**Squeaks & Rattles – Noise from Bulkhead  
Brake Line – Install Isolating Pads & Clip****MODEL** 1995 MY  
Sedan Range  
**VIN**  
720001 - 736560**ISSUE:**

ILLUSTRATION 1

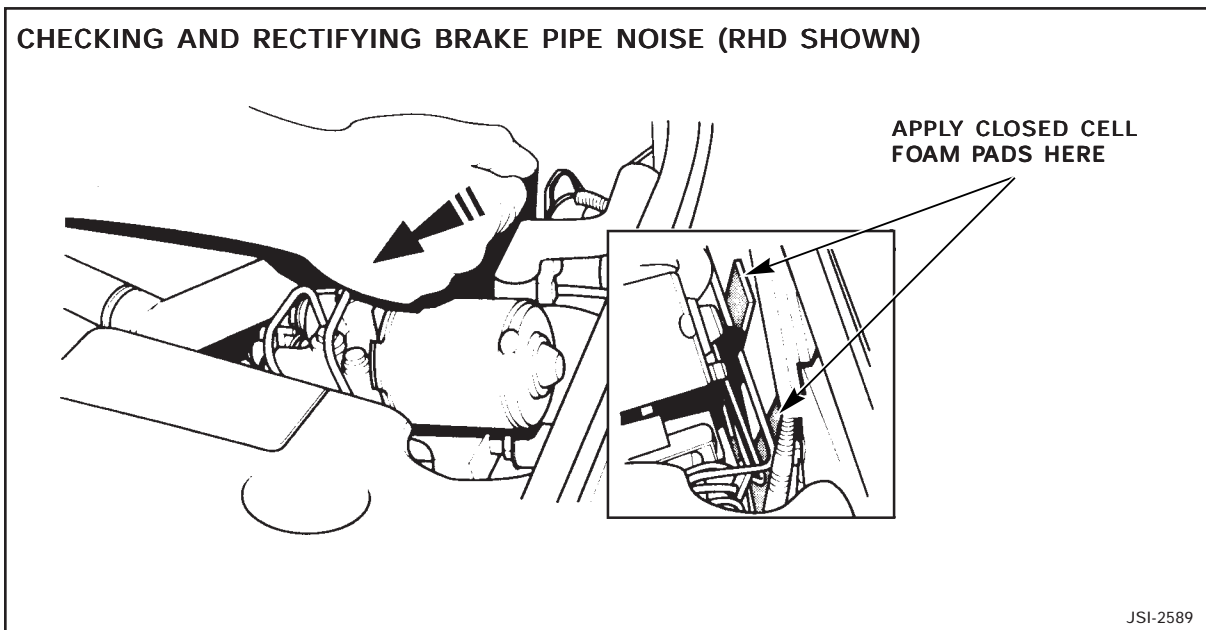
Some 1995 MY Sedan Range vehicles, within the above VIN range, may experience a noise that the customer reports as coming from the right side of the fascia. The source of the noise may actually be in the engine compartment and be caused by contact between a brake line and the bulkhead or between two adjacent brake lines.

If a customer reports a noise from the right side fascia on a 1995 MY Sedan Range vehicle within the above VIN range, check if the noise described by the customer can be reproduced by gently striking the ABS hydraulic unit with the hand as shown in Illustration 1.

1. Clean the surface of the bulkhead and apply two closed cell foam pads (part no. HNA 1210BA) to the locations shown in Illustration 1, to prevent direct contact between the pipes and the bulkhead.
